UNITED STATES ENVIRONMENTAL PROTECTION AGENCY  
WASHINGTON, D.C. 20460

The Environmental Protection Agency (EPA) inspected the waste emplacement process and procedures at the Department of Energy's (DOE) Waste Isolation Pilot Plant (WIPP) from May 17-19, 2005. Enclosed with this letter is EPA's final emplacement inspection report. This letter and the inspection report will be placed in EPA's public docket.

## **Emplacement Inspection Report**

**EPA INSPECTION No. EPA-WIPP-05021**  
**OF THE**  
**WASTE ISOLATION PILOT PLANT**  
**May 17-19, 2005**

**Figure 3** 4200 pound supersacks on platform to be used if the MgO safety factor falls below 1.67.

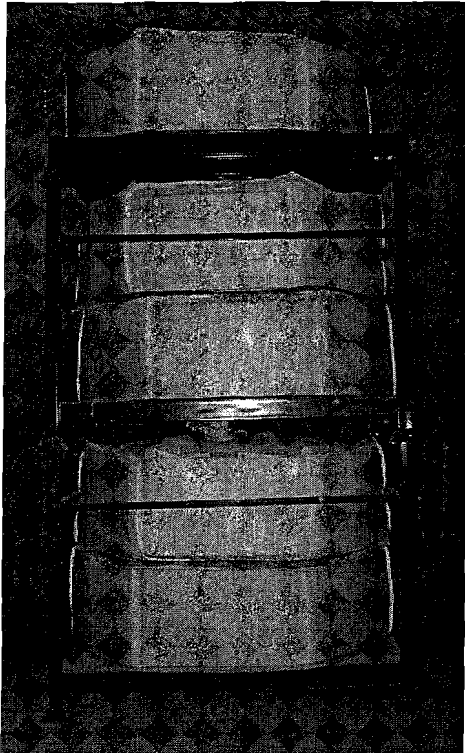
developed for recording the emplaced MgO underground or later entry into the WWIS. The EPA inspectors observed that MgO had been placed properly in each row that was visible. The MgO is placed on top of each waste column in supersacks. However, DOE has developed the option of emplacing additional MgO in racks containing 5 supersacks [Figure 3] if the safety factor falls below 1.67.

Checklist item 7d.  
Supersacks are placed on racks,  
called BRTs (Big Red Things),  
for use if the safety factor is going to be below 1.67.

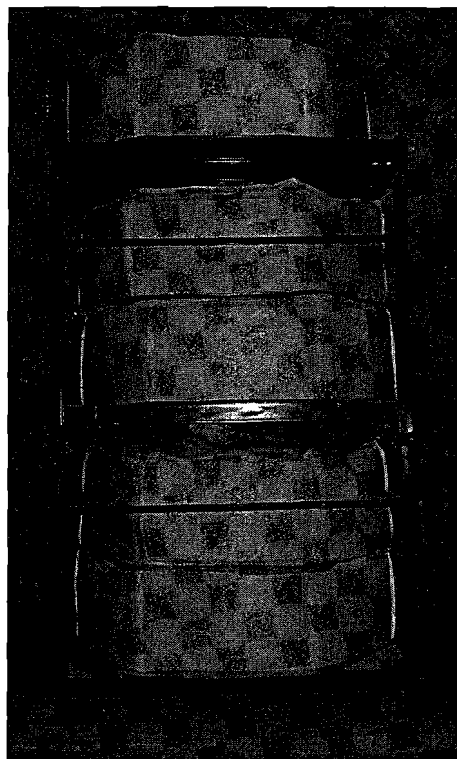
I am responding to the question you had on the BRT. We have data on the compression test of the MgO rack (i.e., BRT). I know that you all understand the operations approach now, which ensures that the bags do not rupture during the emplacement of MgO, and after we get about three rows completed we do not monitor the integrity of the MgO bags/BRT. So our specification data is aimed at keeping the bags from rupturing. I would recommend you all cite Section 3.2 of the MgO specification document (WTS Specification D-0101) that requires that the bags be fabricated to not rupture under their own weight for a minimum of two years (approximate weight of MgO supersacks is 4200 lbs).

As we witnessed in the underground in Panel 3, Room 7 (i.e., the slightly tilted TDOP from floor heave) it is fairly obvious that there will be movement between the waste columns and the MgO rack as the floor heaves, therefore the thin polypropylene bags will be subject to abrasion/tearing/ripping and eventually rupture. Tom, I think you mentioned or maybe it was Chuck that the top bag will rupture as the roof expands and applies pressure (to the top bag) which will disperse MgO around the rack on the disposal room floor as the room begins to creep in and slowly encapsulate the waste and MgO.

- \* Rack (BRT) height is about 140 inches; same height as the other waste columns with MgO bag on top
- \* 57,500 lbs (failure) x 4 legs = 230,000 lbs
- \* Lithostatic pressure is approximately 2150 psi; when applied, it equates to approximately 6,900,000 lbs over the surface area of an MgO sack
- \*  $230,000 \text{ lbs} / 6,900,000 \text{ lbs} = 0.033$  or 3.3%

\* Therefore, the rack legs will fail at approximately 3.3% of the lithostatic load. The thin polypropylene bags around the MgO will fail much sooner than the BRT and at a much smaller percent (maybe an order of magnitude smaller) of the lithostatic load.
